Form No.: 160.00-M1 (LS01)	801
	Supersedes: None	
LITERATURE SUPPLEMENT	File with: 160.00-M1	
Subject: IEEE 519 Logic Board Software Upgrade

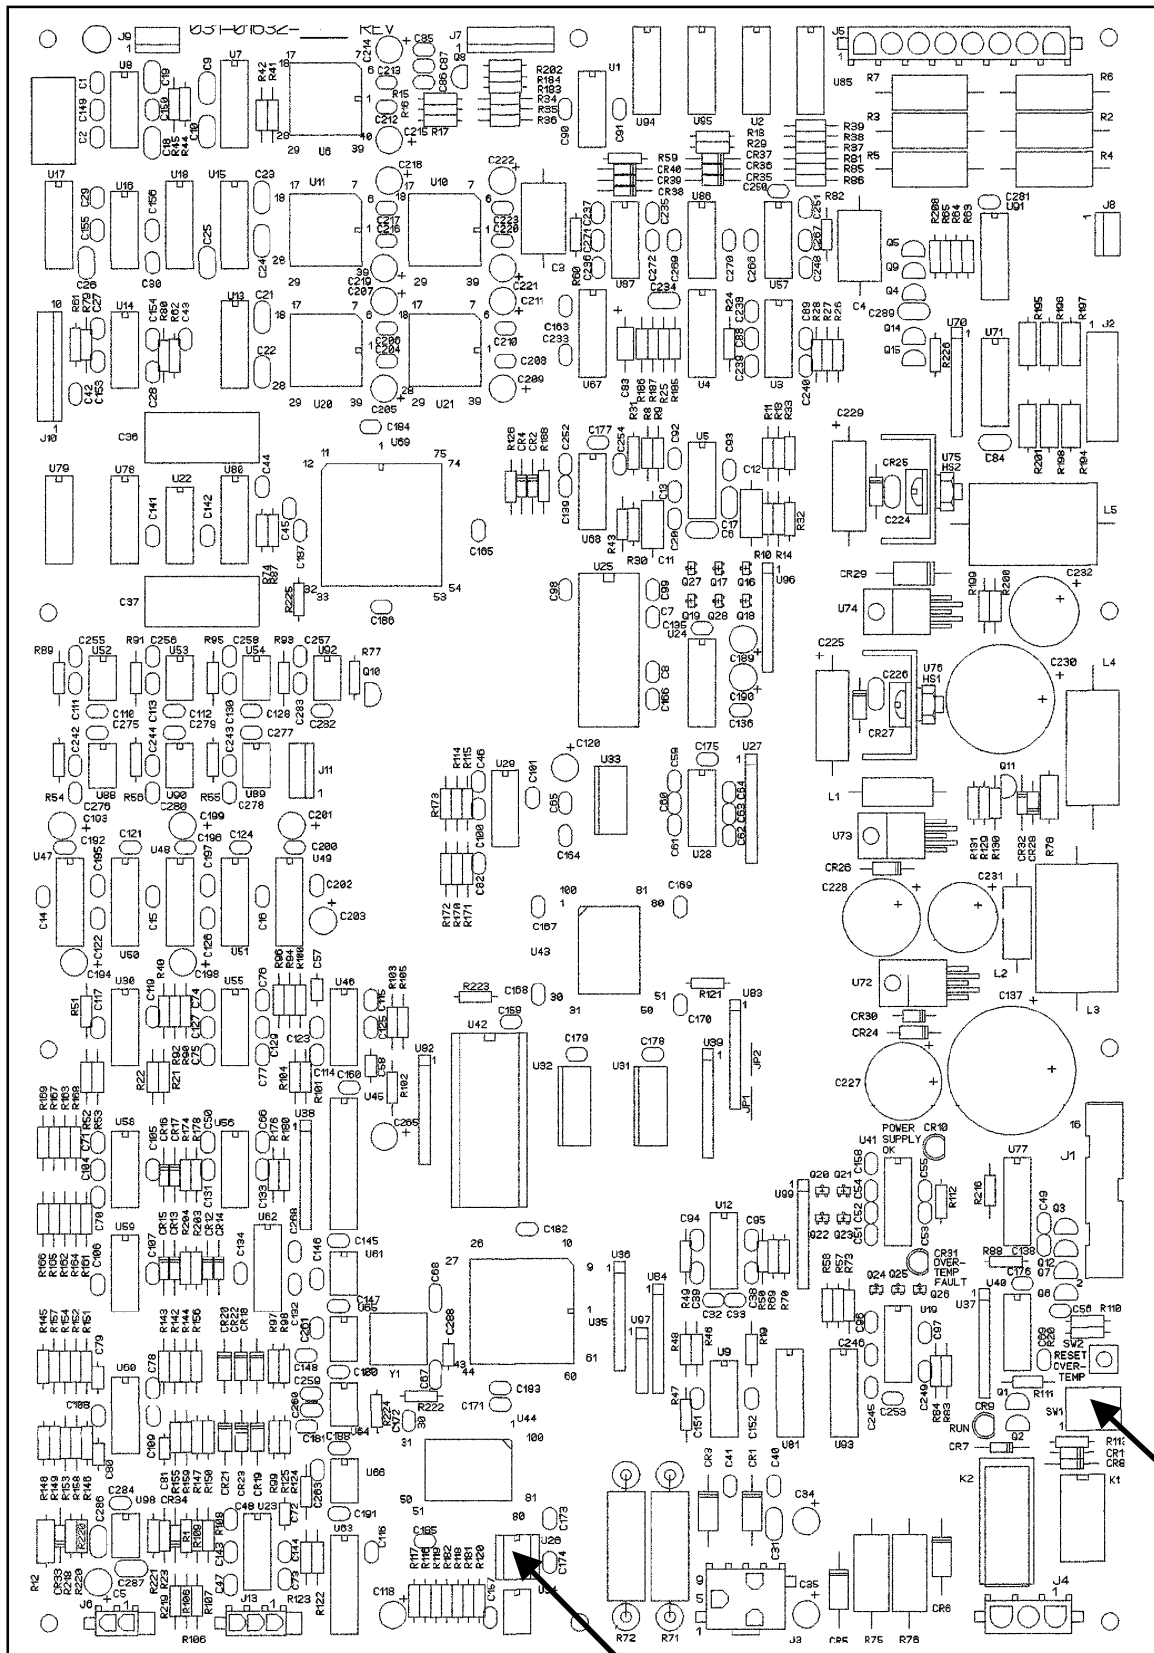
Recent field reports have indicated that chiller shutdowns are sometimes occurring due to the 519 filter having filter phase over current faults. Most of these faults have been caused by the switching of power factor capacitors by the utility, or locally by the customer. These same faults can occur when the customer has a heavily loaded transformer. This software upgrade will eliminate most of the nuisance filter phase over current faults.

If you are experiencing this type of problem with a 519 filter, then order the upgraded U26 chip from the Baltimore Parts Center. The part number for the chip is 031-01680-002 and the check sum is EA3B.

When you receive your part you will find an 8-pin chip to be installed in U26 on the 519 Logic Board. Verify the check sum to be EA3B.

Refer to the back of this sheet for the location of U26 on the logic board. Remove the existing chip in the U26 slot from the 519 filter logic board (031-01632-0XX) and replace it with the new chip from the Baltimore Parts Center check sum EA3B. When installing the new chip ensure that the notch on the chip is pointed toward the top of the board.

If the filter has been disabled, then reconnect the 16 pin ribbon cable between the VSD logic board and the 519 filter logic board. Place SW1 in the up position. Refer to the back of this sheet for the location of SW1.

TOP of BOARD

U26
Note that "notch" is up

SW1
